Addendum 15 – UN Regulation No. 16

Revision 10 - Amendment 6

09 series of amendments – Date of entry into force: 15 June 2024

Uniform provisions concerning the approval of:

"Annex 2

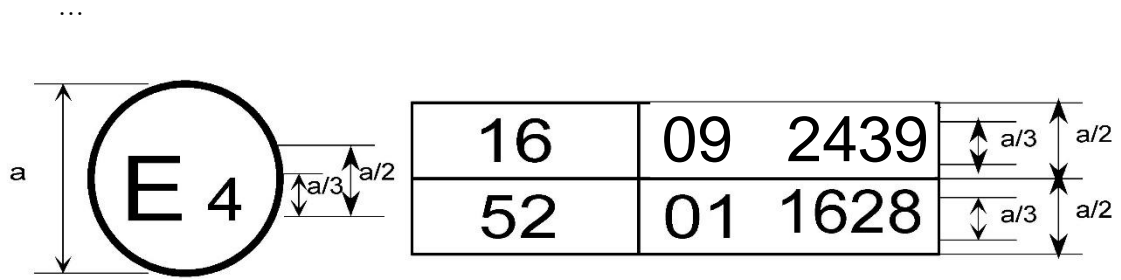
Annex 2, amend to read:

The above ... amended by the 09 series of amendments.

The above ... included the 09 series of amendments and Regulation No. 52 the 01 series of amendments.

2. Arrangements of the safety-belt approval marks (see paragraph 5.3.5. of this Regulation)

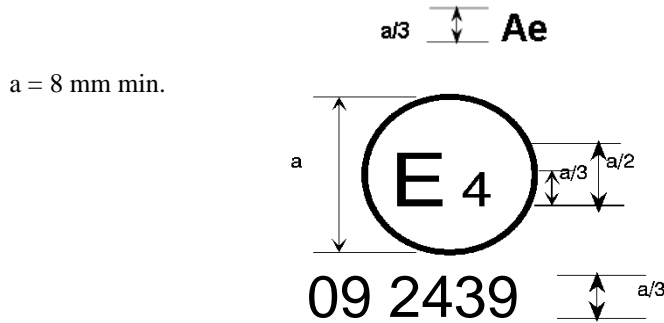
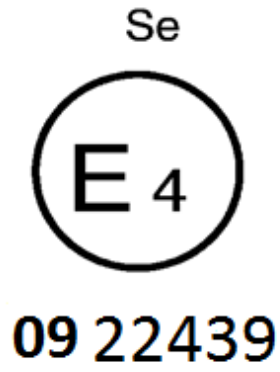
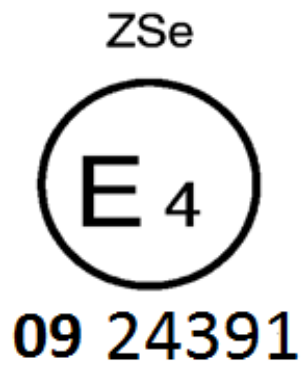
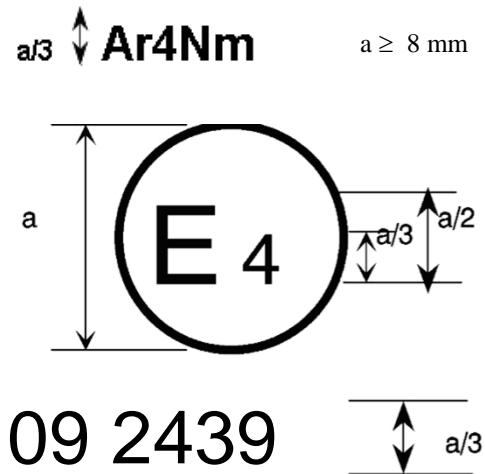
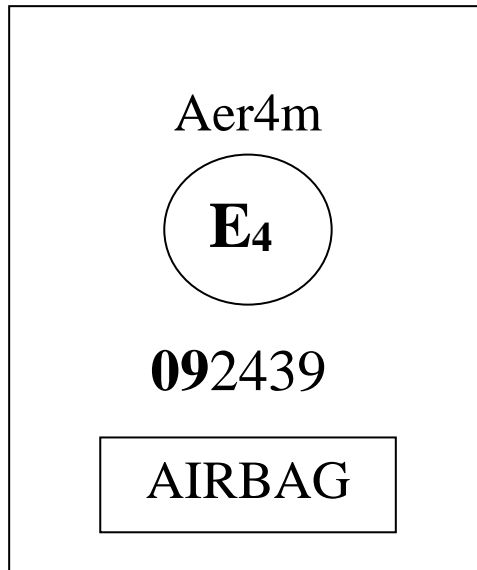
The belt ... the 06, 07, 08 or 09 series of amendments at the time of approval.

The belt ... 06, 07, 08 or 09 series of amendments at the time of approval.

The belt bearing ... the 06, 07, 08 or 09 series of amendments at the time of approval.

The belt ... the 06, 07, 08 or 09 series of amendments at the time of approval.

The belt ... the 06, 07, 08 or 09 series of amendments at the time of approval. This belt shall not be fitted to vehicles of category M₁.

The ... 06, 07, 08 or 09 series of amendments at the time of the approval. This safety-belt has to be fitted to a vehicle equipped with an airbag in the given seating position."
